Re: Proposed Revision to the State Implementation Plan for PM2.5 for Allegheny County – Liberty-Clairton Area Attainment Plan

## **Executive Summary for Comments of Citizens for Pennsylvania's Future and The Group Against Smog and Pollution on the Proposed Attainment Demonstration for the Liberty-Clairton PM2.5 Nonattainment Area**

**COMMENTS OF CITIZENS FOR PENNSYLVANIA'S FUTURE AND THE  
GROUP AGAINST SMOG AND POLLUTION ON THE PROPOSED  
ATTAINMENT DEMONSTRATION FOR THE LIBERTY-CLAIRTON PM2.5  
NONATTAINMENT AREA**

**Figure 1: Occupied Homes in Areas Modeled to Exceed the 15  $\mu\text{g}/\text{m}^3$  Annual Standard**

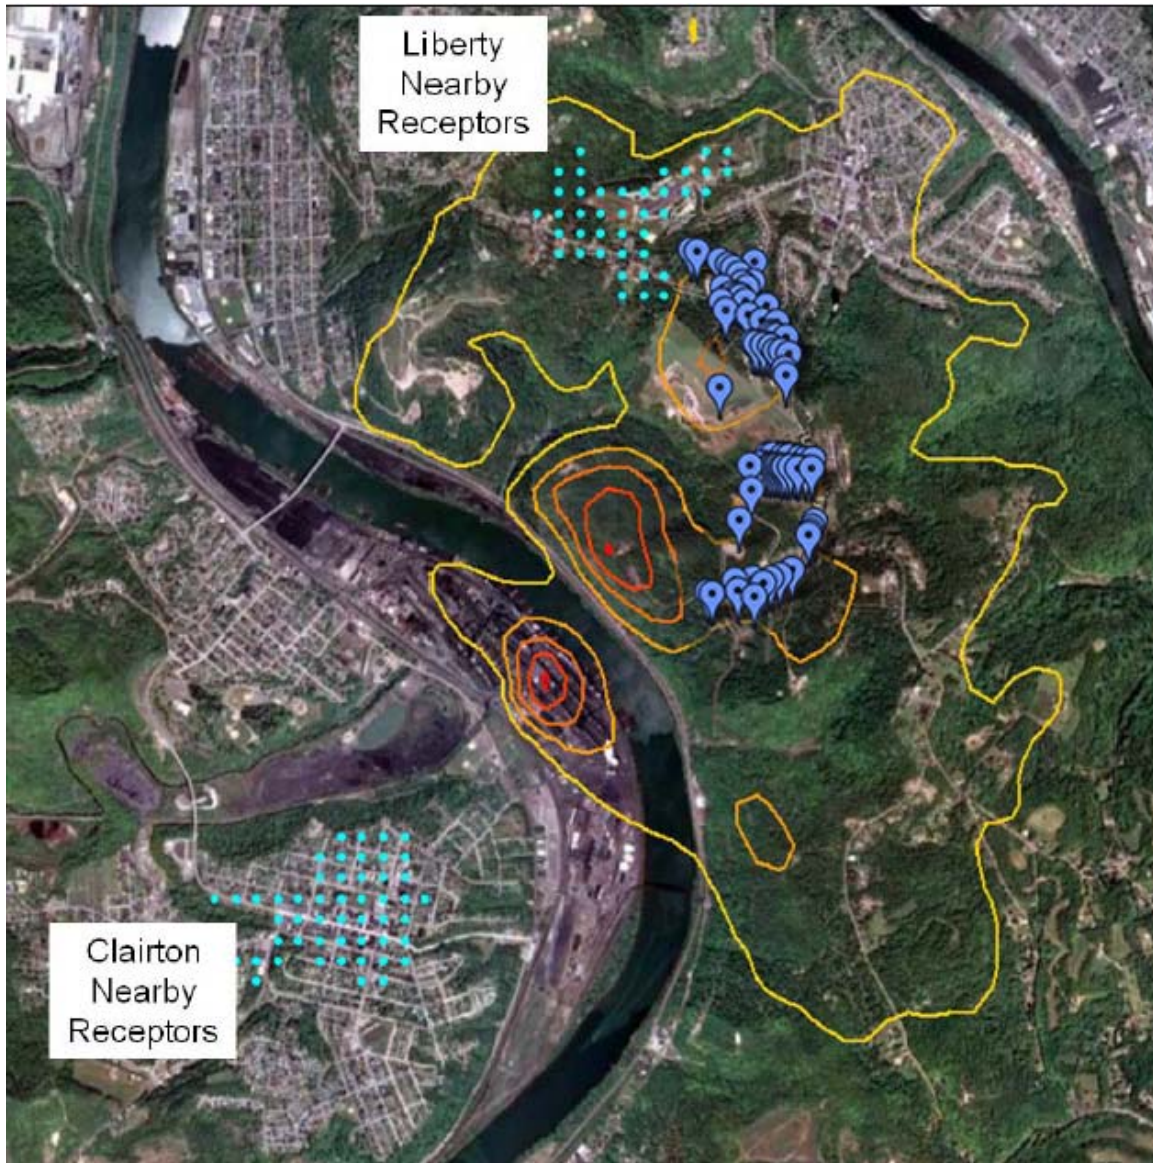
The SIP’s analysis does not fully satisfy EPA’s guidance because it does not quantify the incremental concentrations in this area, which must be known to determine the extent of additional control measures that are needed to achieve the emission reductions that would provide for attainment in this area. Despite this omission, the analysis provided by the ACHD nonetheless shows that the NAAQS will not be met in this area because the attainment demonstration for the Liberty Borough monitor predicts that the annual concentration at that location in 2015 will be 14.9996 µg/m<sup>3</sup>, only 0.0004 µg/m<sup>3</sup> less than the maximum concentration permitted under the NAAQS. The higher, but unquantified, concentrations in the Lincoln area will obviously violate the NAAQS.

The SIP attempts to justify this omission by arguing that the health and welfare of the residents in this high pollution zone may be sacrificed because “the Lincoln hillside is not suitable as a neighborhood-scale location for analyzing PM<sub>2.5</sub> because it does not represent a populated area.”<sup>7</sup> To test this assertion, GASP surveyed the area expected to be affected (within red and orange lines marked on Figure 8-1), and found 80 occupied homes.<sup>8</sup> The residents of this neighborhood must not be consigned to lifelong exposure to pollutant levels that are known to be deadly.
